Inspection of Automatic Sprinkler System

Feltex Automotive - East London
Industrial Development Zone - AE4

UNC.10604

Photo 3

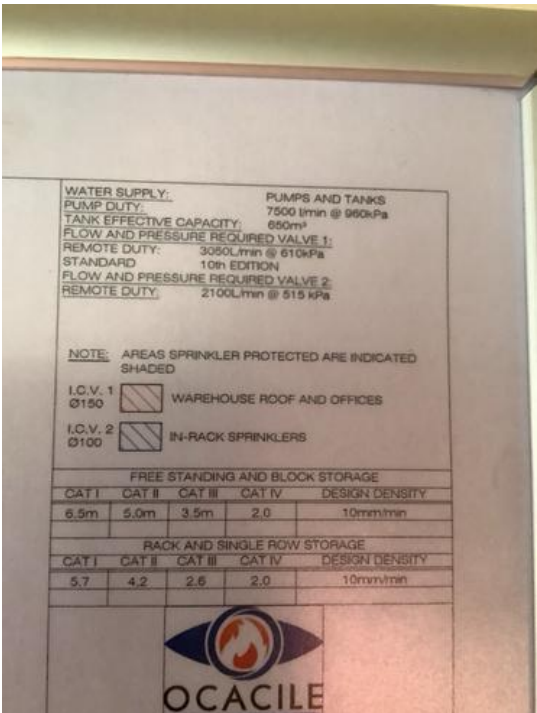
No

A block plan must be provided with the following indicated thereon:

Photo 23

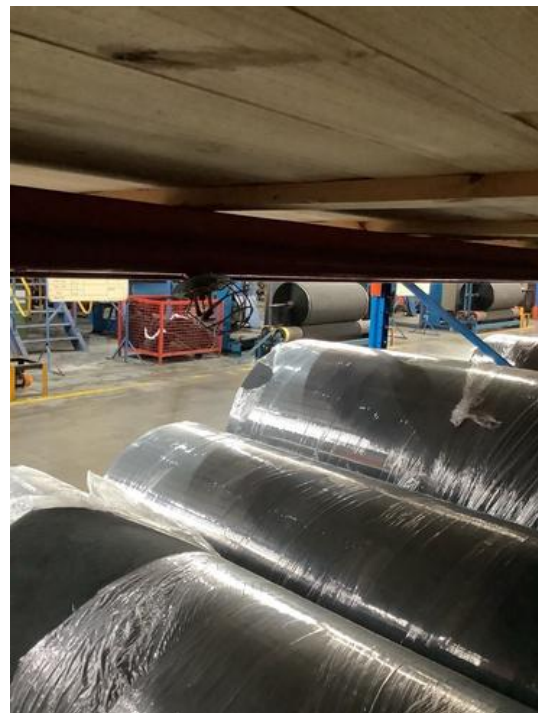
Portion of premises sprinkler protected with communicating sections that are not.

Partial protection can lead to a fire originating in the protected area radiating heat into the unprotected portion of the premises and starting secondary fires. The heat from these fires radiates or spreads back into the protected area causing excessive sprinkler operation.

Photo 27

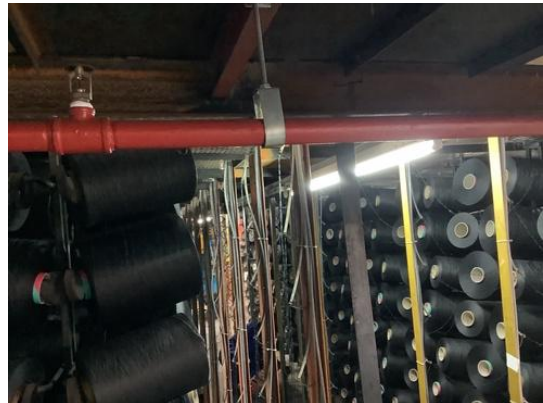
Sprinkler protection must be extended in order to provide correct coverage.

Sprinklers are out of effective working distance.

Photo 33

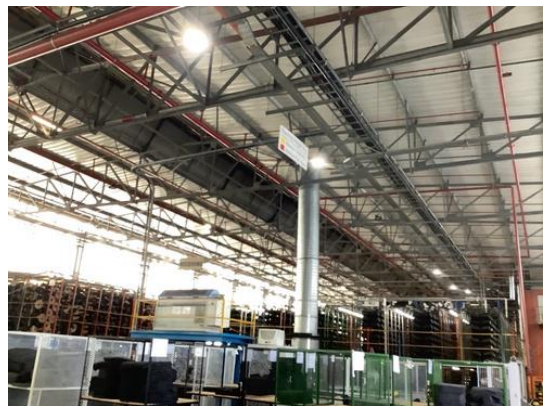
The sprinkler pipe work must be correctly supported.

Belt-to-belt hangers utilized.

Belt-to-belt hangers must be removed and the pipe work correctly supported.
